# Access Compliance Report

## Public Rights-of-Way

Intersection ID: 46788	Main Street: STOWE_ACRES_DR	Cross Street: ALMOND_HILLS_DR	Location: NE
ADA ID: 75181AE20D6A	Ramp Type: PerpDiag	Initial Pass/Fail: Fail	Overall Compliance: No
Severity Score: 22.5			
Codes/Mitigation Info/Possible Solution		Field Measurements/Component Compliance

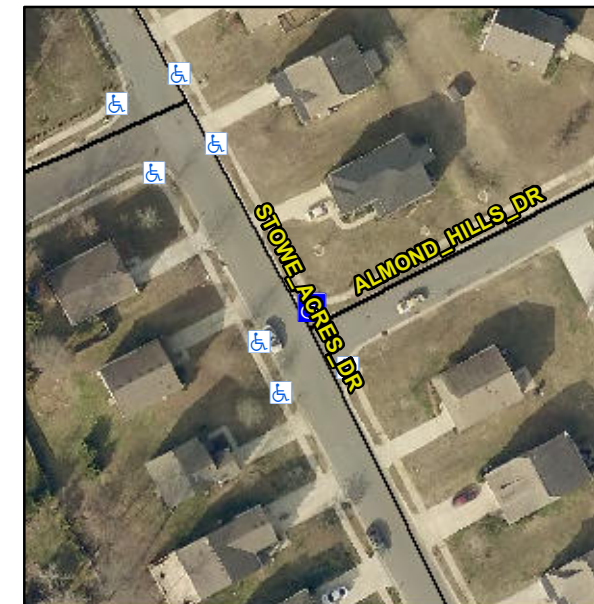
**Not Found, R304.5.1, R304.2.2, R304.5.3**

Compliance	Description	Data	Compliance	Description	Data
N/A	Ramp Length (in)	48.0	No	Ramp Slope (%)	9.0
No	Ramp Width (in)	37.0	No	Ramp XSlope (%)	2.2
N/A	Flare Type LT	N/A	N/A	Flare Type RT	N/A
N/A	Flare Slope LT (%)	N/A	N/A	Flare Slope RT (%)	N/A
N/A	Flare Traversable LT?	N/A	N/A	Flare Traversable RT?	N/A
N/A	Landing Length (in)	N/A	N/A	DWS Provided?	N/A
N/A	Landing Width (in)	N/A	N/A	DWS Contrast?	N/A
N/A	Landing Slope (%)	N/A	N/A	DWS Length (in)	N/A
N/A	Landing X Slope (%)	N/A	N/A	DWS Full Width?	N/A
N/A	Landing Curb? (Y/N)	N/A	N/A	DWS Offset (in)	N/A
N/A	Shared Landing?	N/A			
N/A	Gutter Ponding?	N/A	N/A	Gutter Slope (%)	N/A
N/A	Gutter Lip Ht (in)	N/A	N/A	Gutter X Slope (%)	N/A
N/A	Painted X Walk1?	No	N/A	Painted X Walk2?	No
	X Walk 1 Direction	To W		X Walk 2 Direction	To S
N/A	X Walk 1 Width (in)	N/A	N/A	X Walk 2 Width (in)	N/A
	X Walk 1 Slope (%)	2.8		X Walk 2 Slope (%)	1.0
	X Walk 1 X Slope (%)	1.0		X Walk 2 X Slope (%)	2.2

**Remove & Replace Curb Ramp With Two New Directional Ramps or Equivalent.**
